Access Compliance Report

Public Rights-of-Way

Intersection ID: 47845	Main Street: DEL_RIO_RD	Cross Street: CACTUS_VALLEY_RD	Location: NW
ADA ID: EBF3CE5EF27A	Ramp Type: PerpDiag	Initial Pass/Fail: Fail	Overall Compliance: No
			Severity Score: 21.25

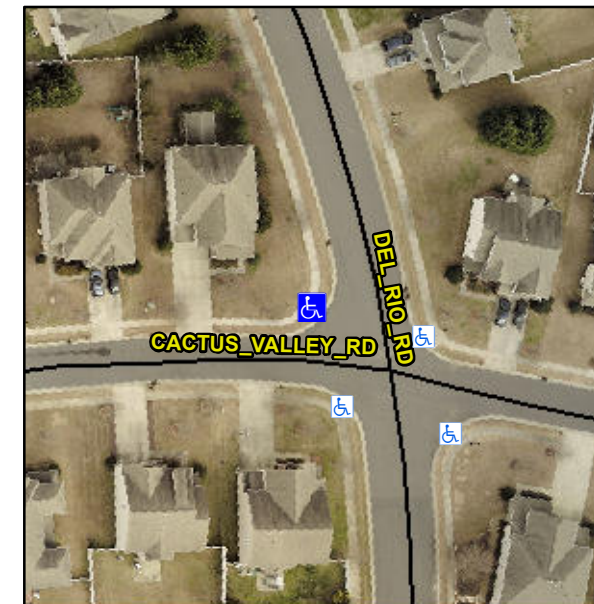
Not Found, R304.5.1, R304.5.3

Compliance	Description	Data	Compliance	Description	Data
N/A	Ramp Length (in)	60.0	Yes	Ramp Slope (%)	8.0
No	Ramp Width (in)	47.0	No	Ramp XSlope (%)	5.6
N/A	Flare Type LT	N/A	N/A	Flare Type RT	N/A
N/A	Flare Slope LT (%)	N/A	N/A	Flare Slope RT (%)	N/A
N/A	Flare Traversable LT?	N/A	N/A	Flare Traversable RT?	N/A
N/A	Landing Length (in)	N/A	N/A	DWS Provided?	N/A
N/A	Landing Width (in)	N/A	N/A	DWS Contrast?	N/A
N/A	Landing Slope (%)	N/A	N/A	DWS Length (in)	N/A
N/A	Landing X Slope (%)	N/A	N/A	DWS Full Width?	N/A
N/A	Landing Curb? (Y/N)	N/A	N/A	DWS Offset (in)	N/A
N/A	Shared Landing?	N/A			
N/A	Gutter Ponding?	N/A	N/A	Gutter Slope (%)	N/A
N/A	Gutter Lip Ht (in)	N/A	N/A	Gutter X Slope (%)	N/A
N/A	Painted X Walk1?	No	N/A	Painted X Walk2?	No
	X Walk 1 Direction	To S		X Walk 2 Direction	To SE
N/A	X Walk 1 Width (in)	N/A	N/A	X Walk 2 Width (in)	N/A
	X Walk 1 Slope (%)	1.8		X Walk 2 Slope (%)	2.4
	X Walk 1 X Slope (%)	3.9		X Walk 2 X Slope (%)	3.1

Remove & Replace Curb Ramp With Two New Directional Ramps or Equivalent.
